PERMIT DOCUMENTS FOR TRAIL RIDGE LANDFILL THIRD RAI RESPONSE

MAY 15, 2003

**RE: Trail Ridge Landfill – Second Permit Renewal
FDEP Permit Numbers 0013493-001 and 0013493-002
FDEP File Numbers 13493-010 and 13493-011
Third Request for Additional Information
ETM No. 02-025-3**

JOB NO. 6734-03-8666 SHEET 1 OF 3
PHASE _____ TASK CALCULATIONS FOR SLIDING SLOPE STABILITY
JOB NAME TRAIL RIDGE LANDFILL
BY J.S.S. DATE 4-28-03
CHECKED BY BSA DATE 5-9-03

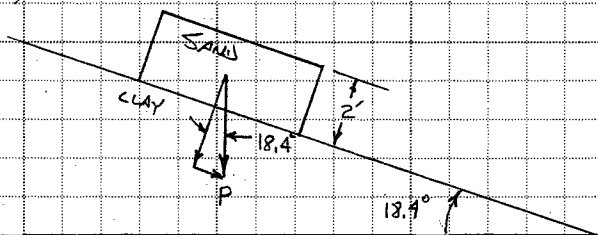
Please provide all supporting calculations including those you conducted to determine Q. Also, please indicate and justify how you determine each of the values factored into the equations, i.e., h, B, beta, geonet thickness, and etc. Please also clarify what each factor

Please see the response from MACTEC in **Attachment C**.

Trail Ridge Landfill Vertical Expansion Landfill Material Phi (Degrees) = 27
 Ten Most Critical. C:TRL27.PLT By: JSS 05-01-03 3:49 pm

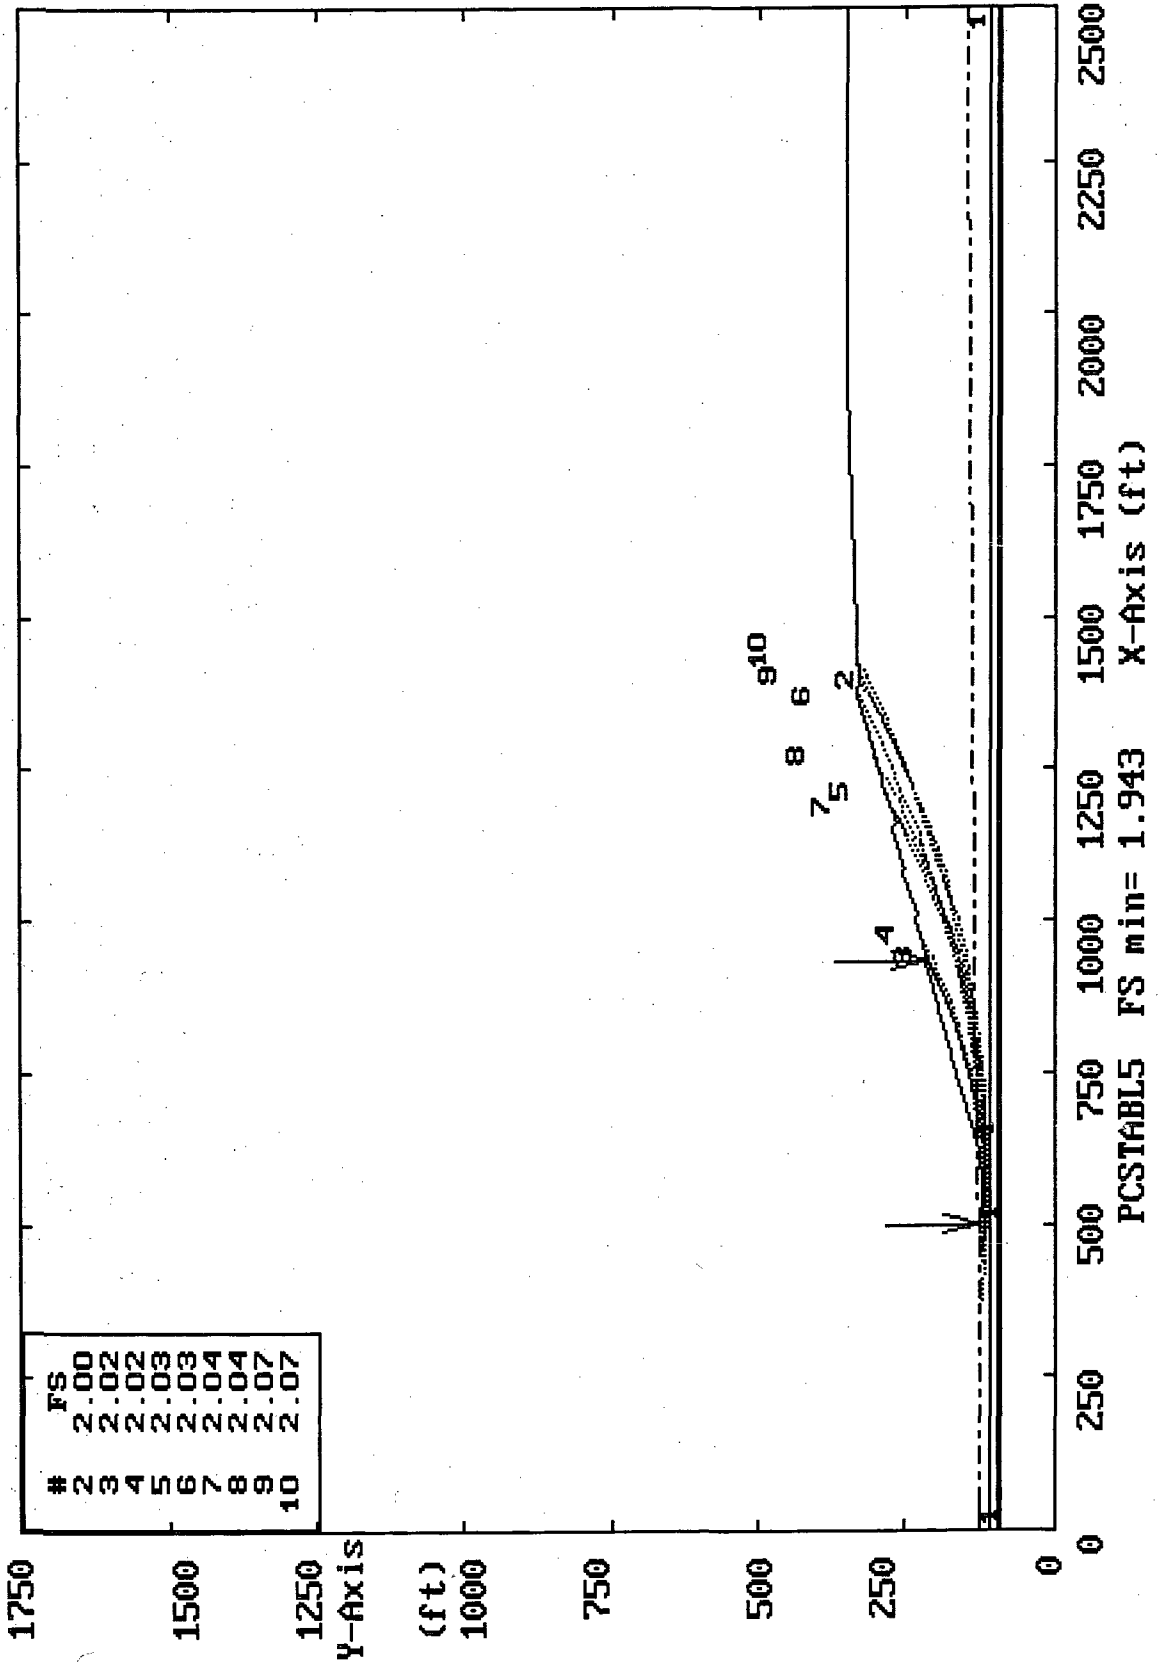
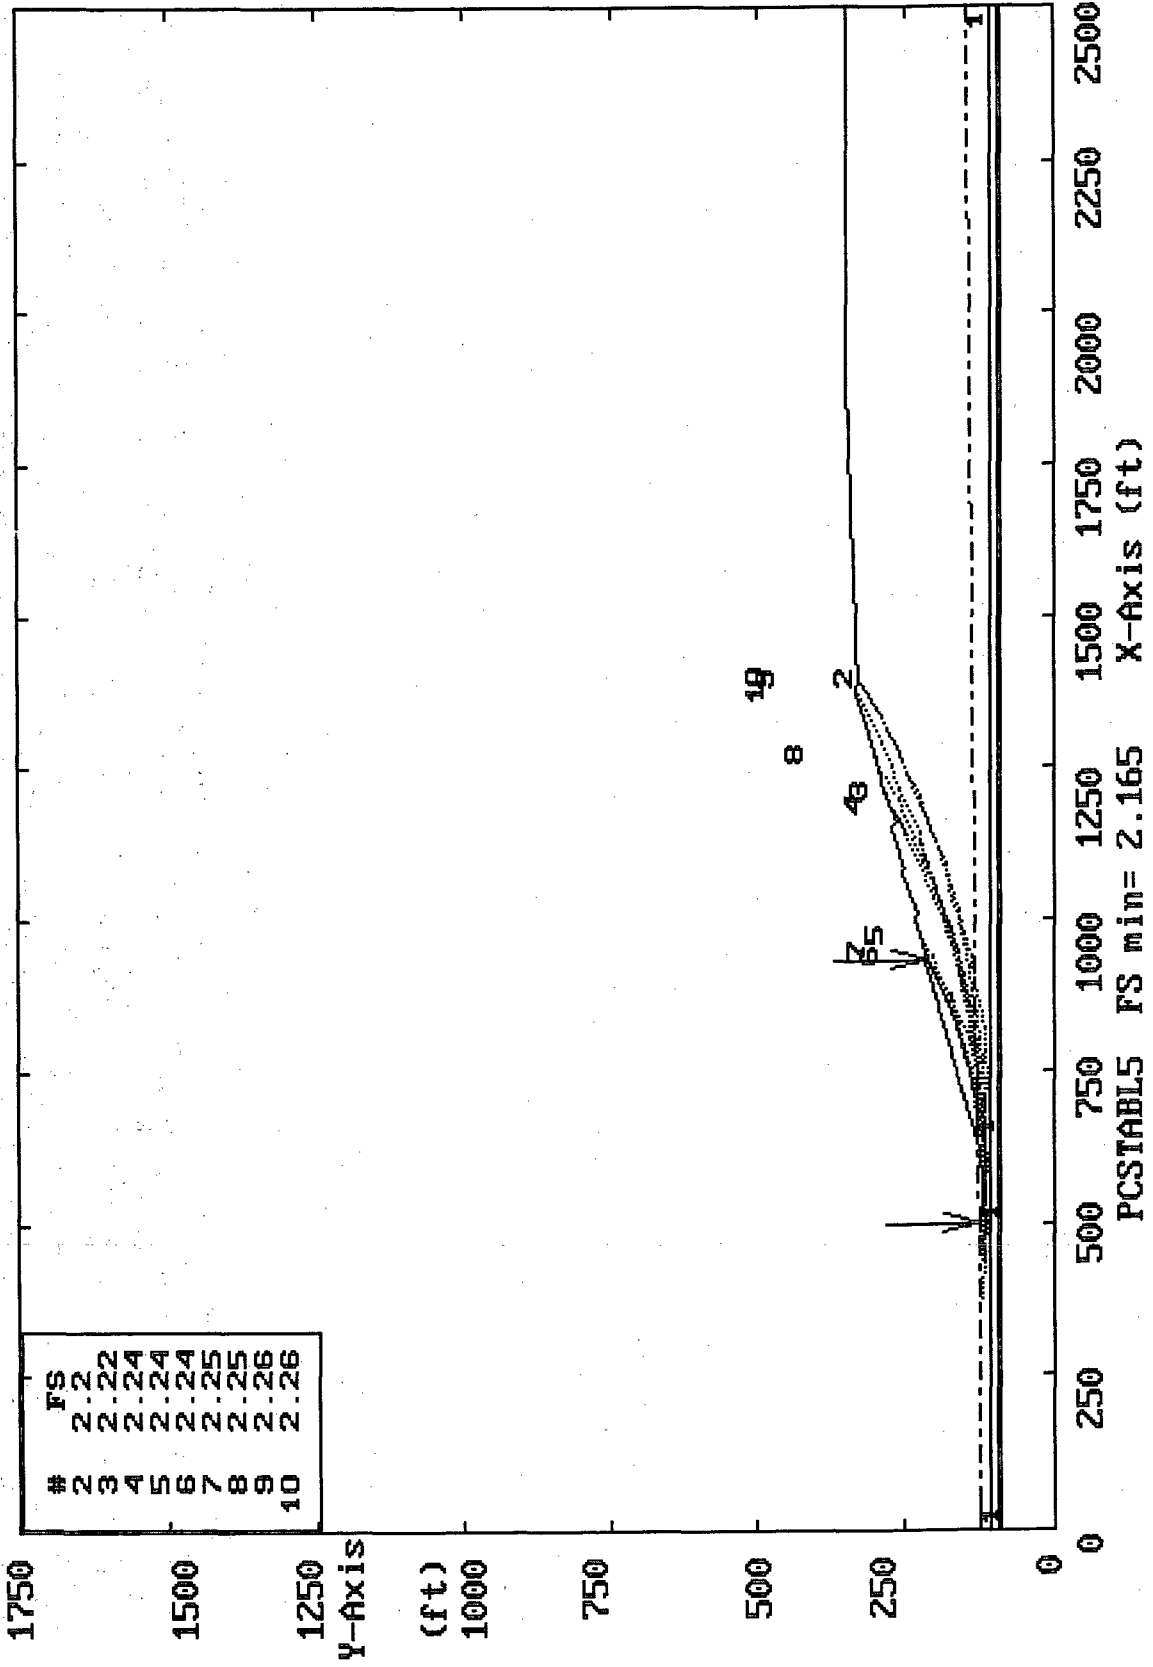
Please show the surface boundary you are modeling. Also, please show the failure surfaces and the points of convergence at a minimum.

- i) *Please show the surface boundary you are modeling. Also, please show the failure surfaces and the points of convergence at a minimum.*

Please see the response from MACTEC in Attachment C.
